**DEPARTMENT OF TRANSPORTATION
STATE OF GEORGIA**

SUBJECT PROJECT CONCEPT REPORT APPROVAL

JOHNSON ROAD OVER PEEKS CREEK BRIDGE REPLACEMENT

Project No.: BRZLB-121(20)

FIGURE 1
TYPICAL SECTION
JOHNSON ROAD
FULTON COUNTY
BRIDGE REPLACEMENT

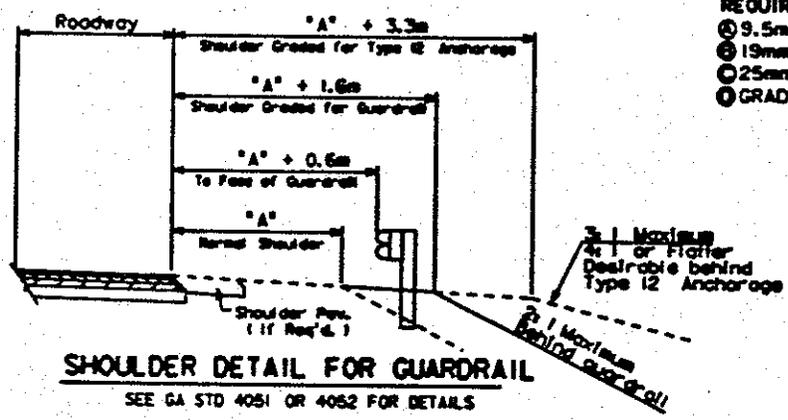
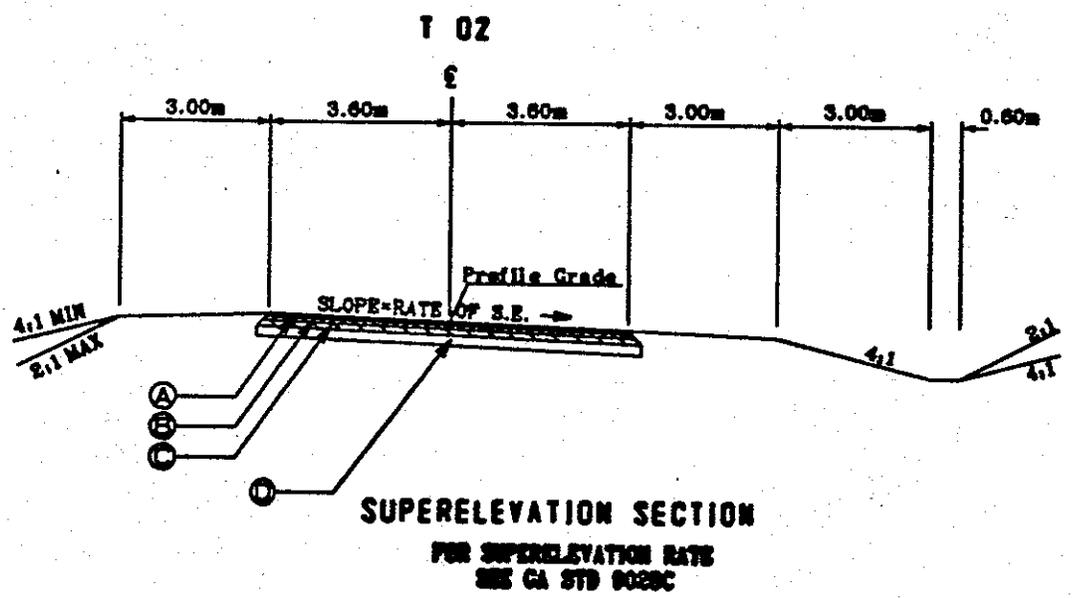
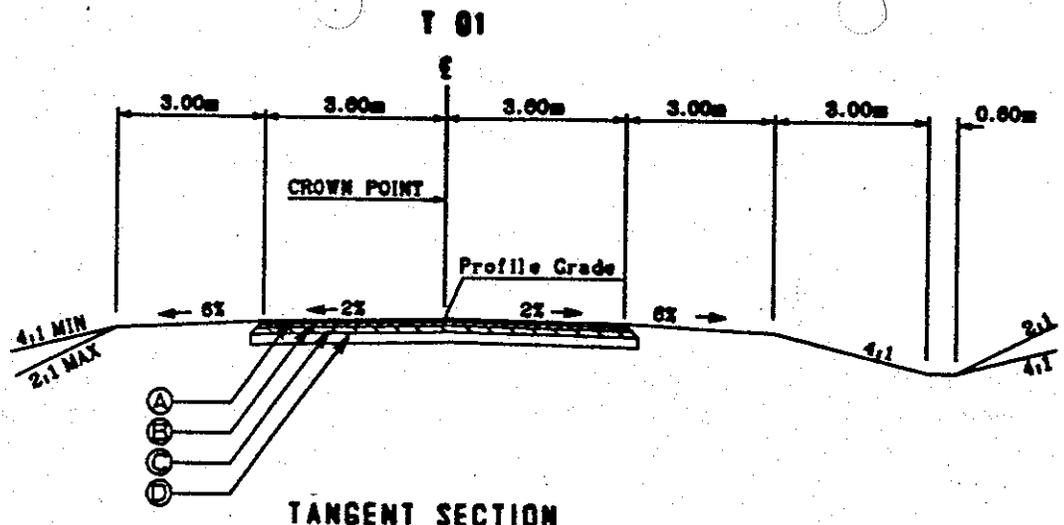
- Typical section is OK.
- Station application of the typical sections on the sketch should be checked or removed.
- Show as "Overlay Section" and "Typical Section" on the sketch.
